ADDITION TO RAY'S ADVENTURE PRELIMINARY PLAN NO. 120200030

Application to create two lots for two single-family detached dwelling units in the R-200 zone.

No. 120200030

RE: Preliminary Plan No. 120200030
Addition to Ray's Adventure
Preliminary Plan Letter

Figure 5: Proposed Preliminary Plan showing Lot 1 and Lot 2 with 11-foot wide sidepath connecting Bush Hill Road with Woodfield Road.

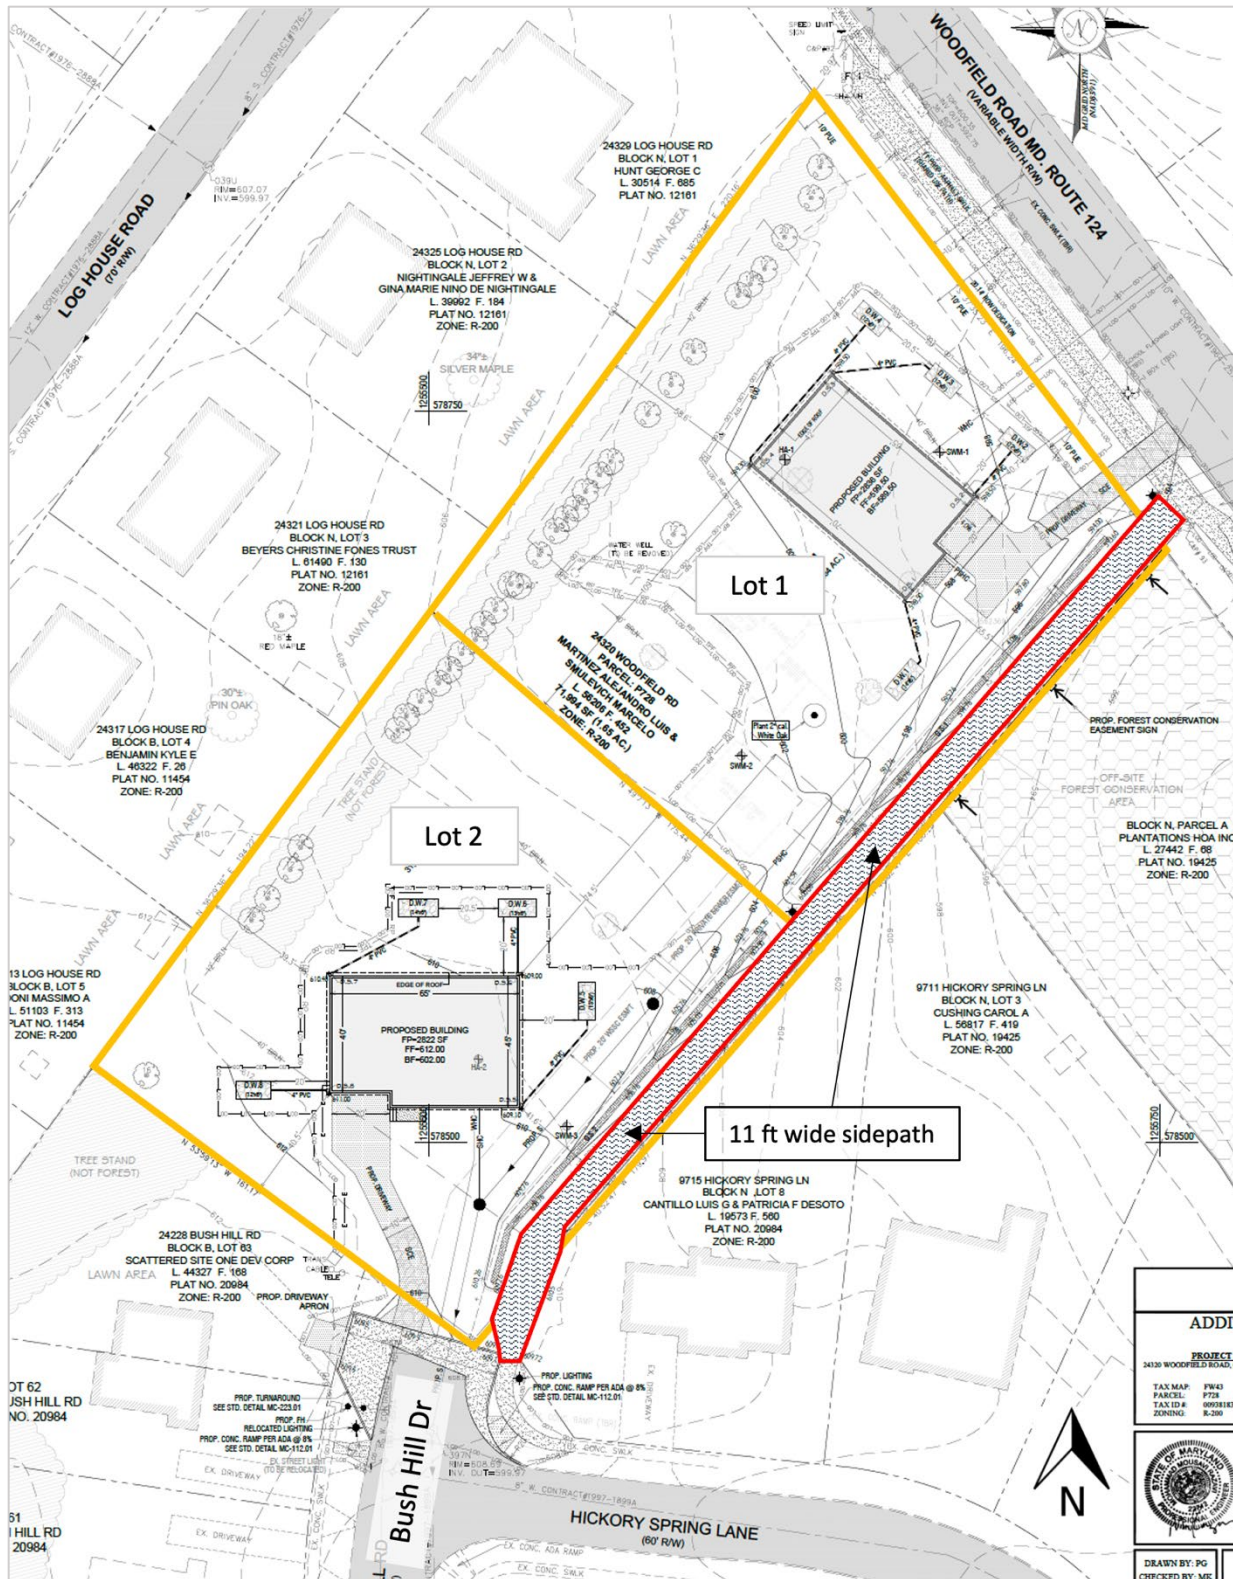
The Applicant will construct an 11-foot wide sidepath along Woodfield Road as recommended in the 2018 *Bicycle Master Plan* (see Figure 5). Additionally, the Applicant will construct an 11-foot-wide asphalt path through Lot 1 and Lot 2 to connect Bush Hill Road with Woodfield Road, addressing Staff’s concern that the neighborhood at present has insufficient bike and pedestrian connectivity to Woodfield Road, particularly to Ride On transit service on that road. Signage will be provided to prohibit vehicular usage of the path. Additionally, there is adequate separation between the Lot 1 driveway and the sidepath to limit conflicts with motor vehicles. A public access and improvement easement will contain the path to accommodate public bike and pedestrian movement. Long term maintenance of the path will be determined at the time of the approval of the site access permit.

Figure 6 - Protected tree to be removed

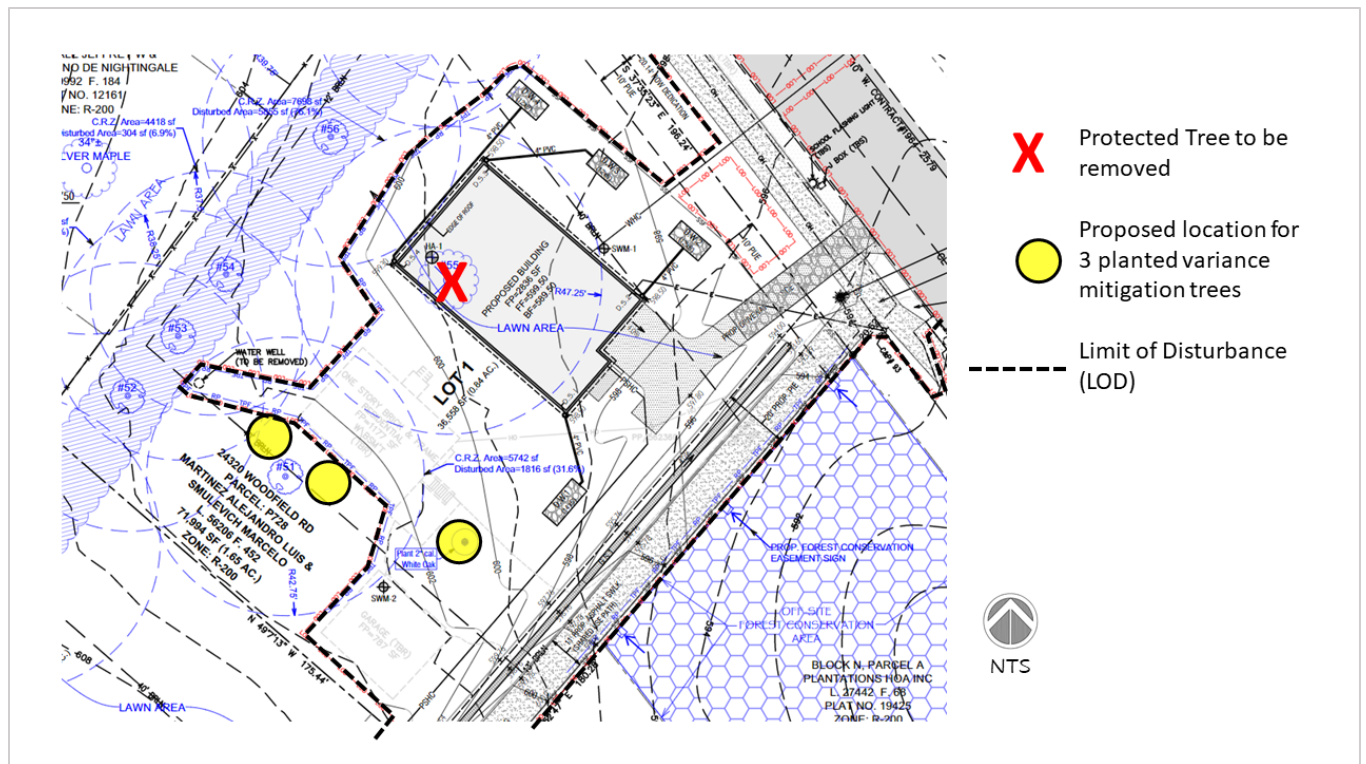
This Application requires the removal or CRZ impact to one (1) Protected Tree as identified in Table 4. The Applicant submitted a variance request letter dated February 8, 2023 (Attachment D) for the removal of one Protected Tree (Figure 6) for the construction of the proposed house on Lot 1. Section 22A-21 of the County Forest Conservation Law sets forth the findings that must be made for a variance to be granted.

In this case, the unwarranted hardship is caused by the existing site conditions, the location of the Protected Tree on Lot 1, the setback requirements in Sec. 4.4.7 and the established building line in Sec. 4.4.1 of the Zoning Ordinance. Tree No. 55 is located approximately in the middle of Lot 1 and centrally located within the developable portion of the lot. The front setback and the established building line necessitate the location of the home toward the front of the lot and put the home on top

of Tree No. 55. In addition, there is virtually no practical location within the developable area on the lot that would prevent the removal of Tree No. 55. Therefore, there is a sufficient unwarranted hardship to justify a variance request because the Applicant would otherwise be denied the ability to use the Subject Property for the approved residential use for one house, which is a reasonable and significant use of the Property.

Staff recommends approval of the variance request.

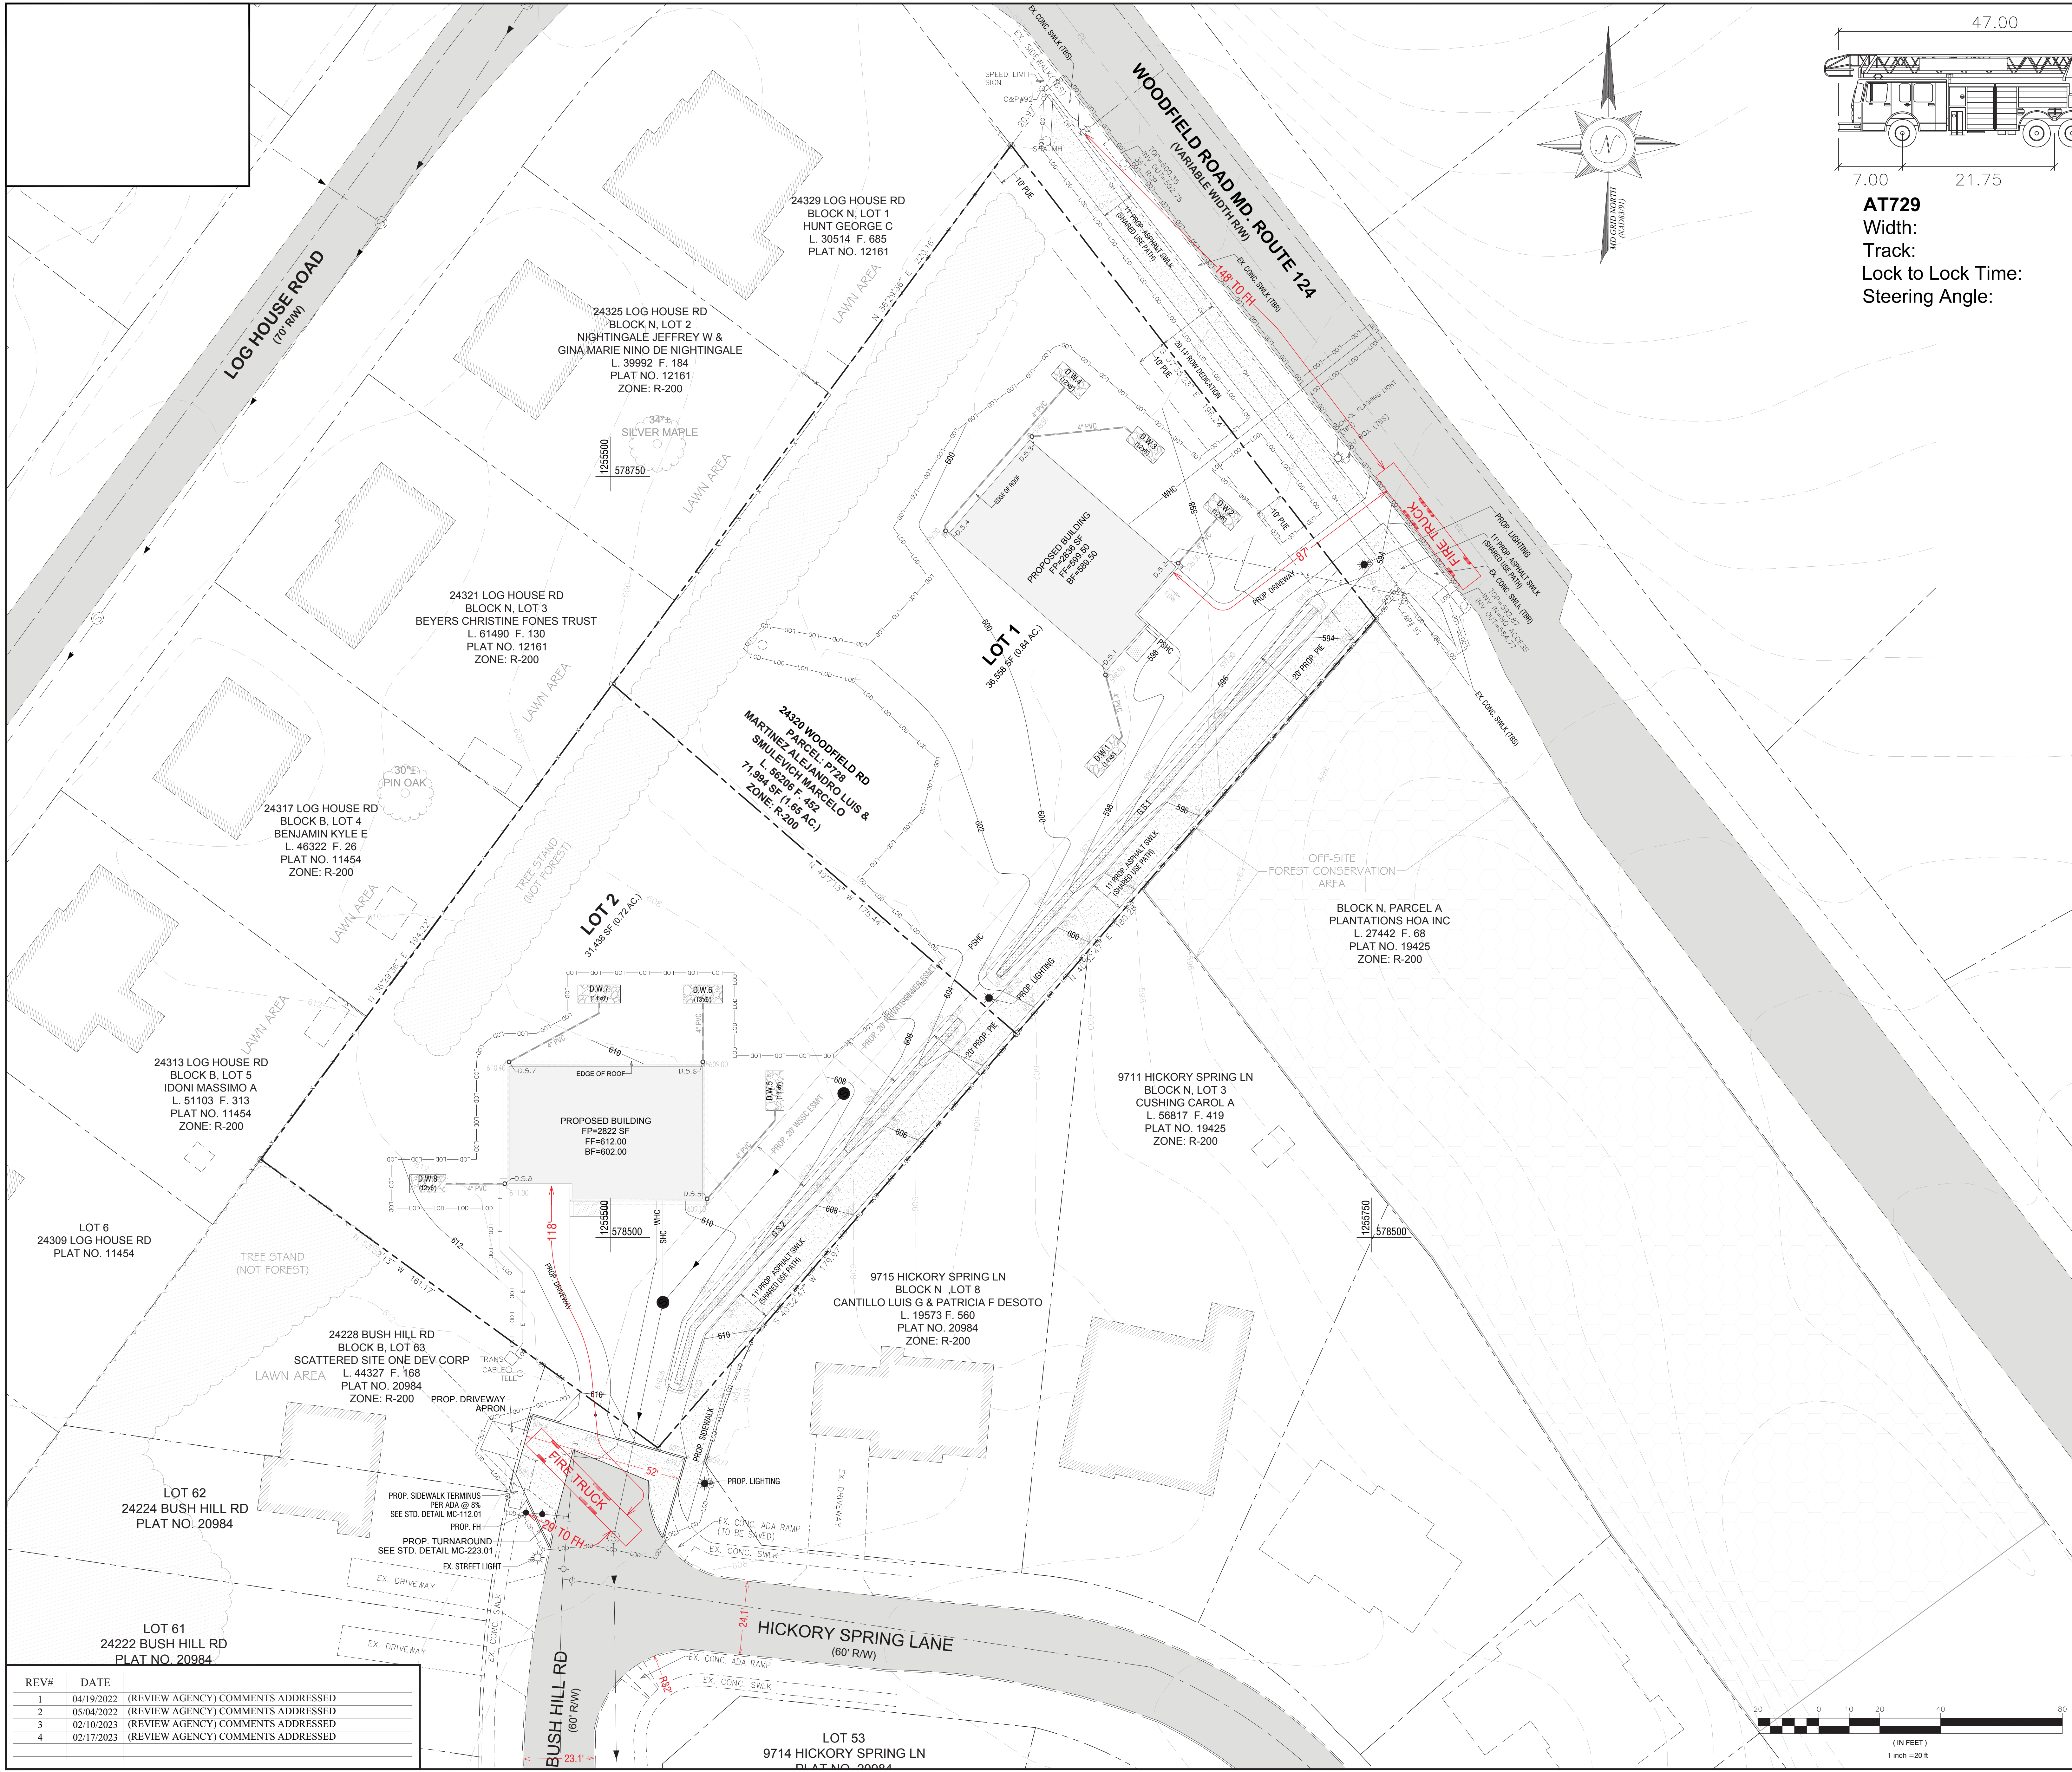
1. Woodfield Road (MD-124):
 - a. Per Bicycle Masterplan: sidepath along the frontage. We recommend the applicant install the sidepath along the frontage with a minimum 6-ft buffer as shown in the plans.
 - b. We defer to Maryland State Highway Administration (MDSHA) for any other improvements along this roadway.
2. Bush Hill Road:
 - c. The proposed Temporary Turnaround as shown in the plan meets the minimum standards per MC-223.01.
 - d. The details of the handicap ramps as shown on the plan will be determined at the right-of-way permit stage by Montgomery County Department of Permitting Services (MCDPS).
 - e. The proposed driveway entrances shall be per MC-301.02

3. At or before the right-of-way permit stage, the applicant shall provide a written consent from the adjacent property owner (exiting Lot 63) which is not part of this application for the modification of their driveway.

4. The proposed 11-ft sidewalk/shared use path along Lots 1 and 2 as shown in the plan is located within a 20-ft public improvement easement (PIE). The applicant shall coordinate with MCDPS at the right-of-way permit (ROW) stage to determine whether the proposed 11-ft sidewalk/shared use path along Lots 1 and 2 shall be maintained by the county or privately maintained. If it is decided to be maintained by the county, then the applicant shall install the sidewalk/shared use path with proper lighting per the county standards. If it is privately maintained a PIE is not required.
